CITY OF ALBUQUERQUE

RE: **Lot 21 Block 1 Volcano Cliffs SAD 227**
6905 Rimrock NW
Grading and Drainage Plan
Engineers Stamp Date 6/15/17 (D10D003D008)

James D. Hughes, P.E.
Principal Engineer, Hydrology
Planning Department

6208 KEYENTA PLACE	DRAWN BY WCVJ
	GRADING AND DRAINAGE PLAN	DATE 6-19-17
6/20/17		21754-LAYOUT-6-19-17
DAVID SOULE P.E. #14522		SHEET #
	1606 CENTRAL AVENUE SE SUITE 201 ALBUQUERQUE, NM 87106 (505) 872-0999	JOB # 21754

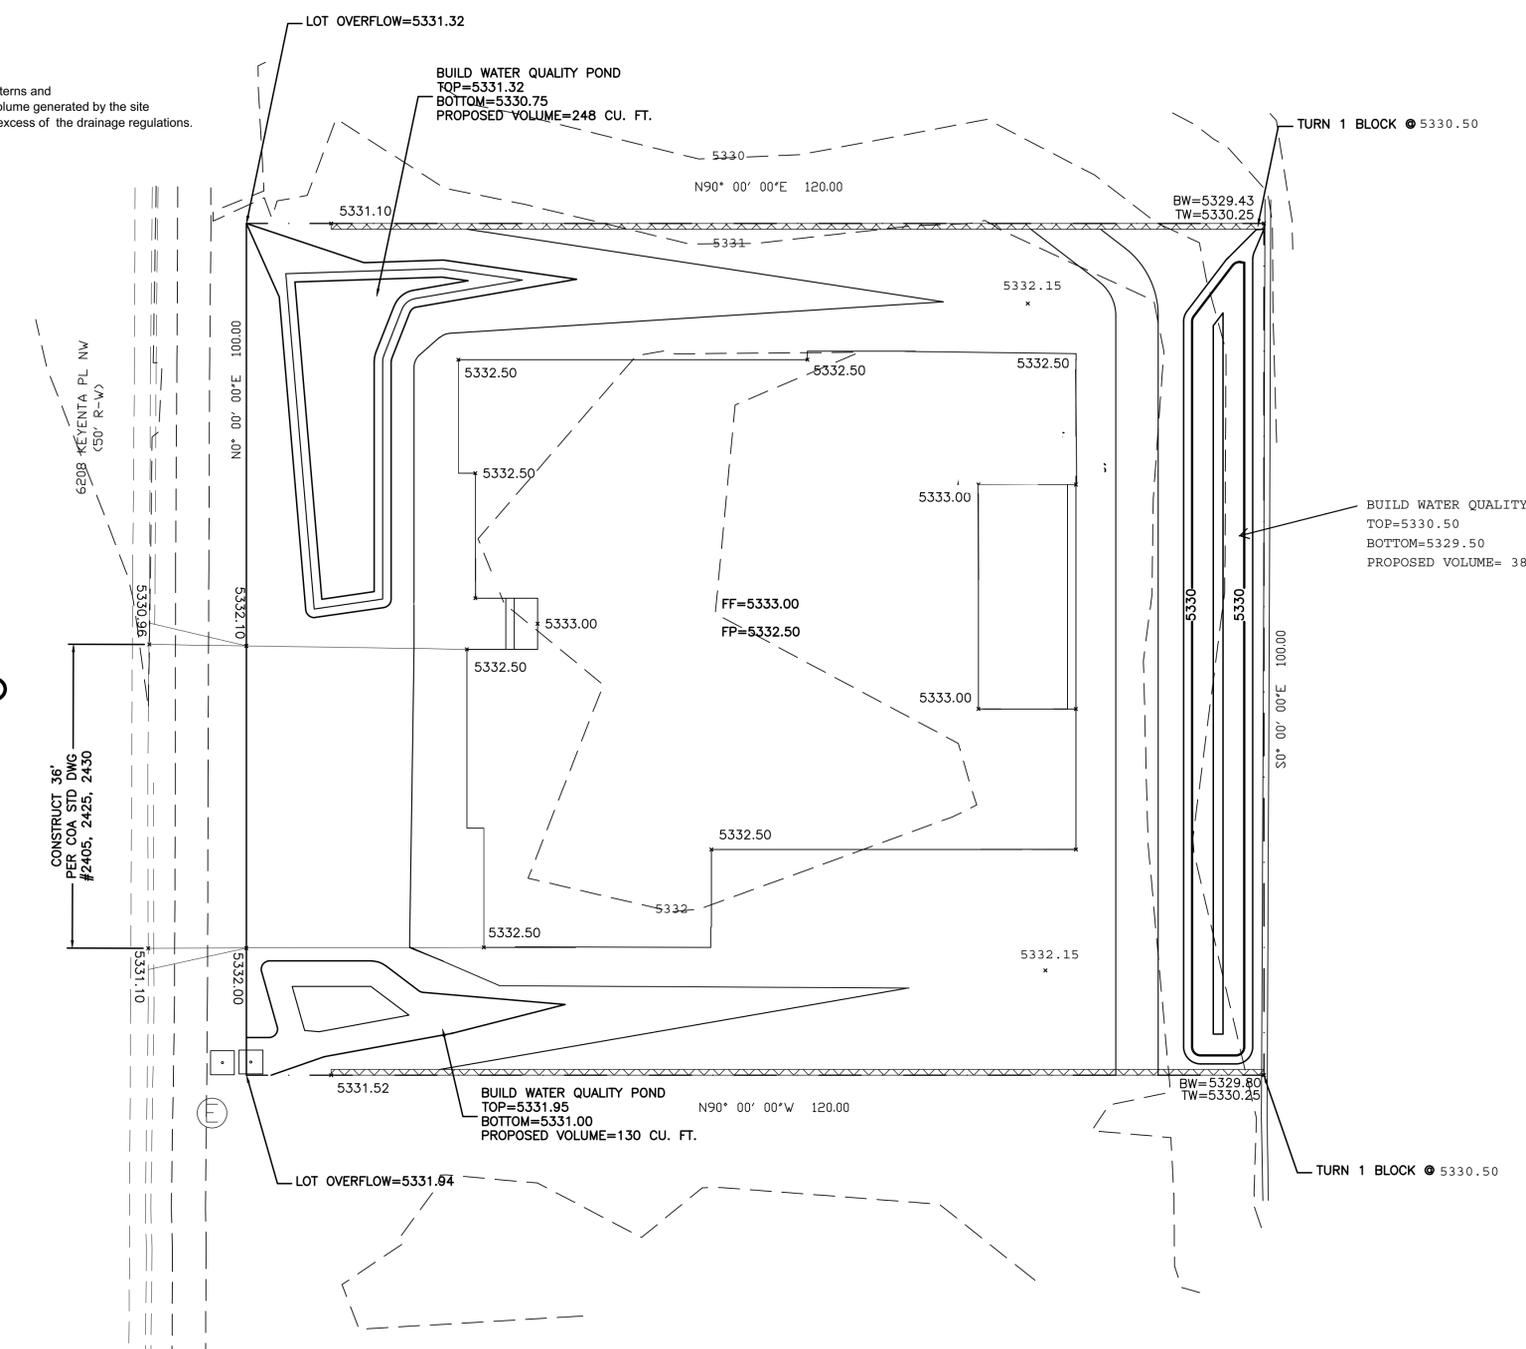
Based upon the information provided in your submittal received 6/21/17, this plan is cannot be approved for Grading Permit until the following comments are addressed.

- Provide a statement on the plan that this grading plan must be used for the application of any garden/retaining walls.
- Provide a statement that a Pad Certification is required before building permit can be approved.
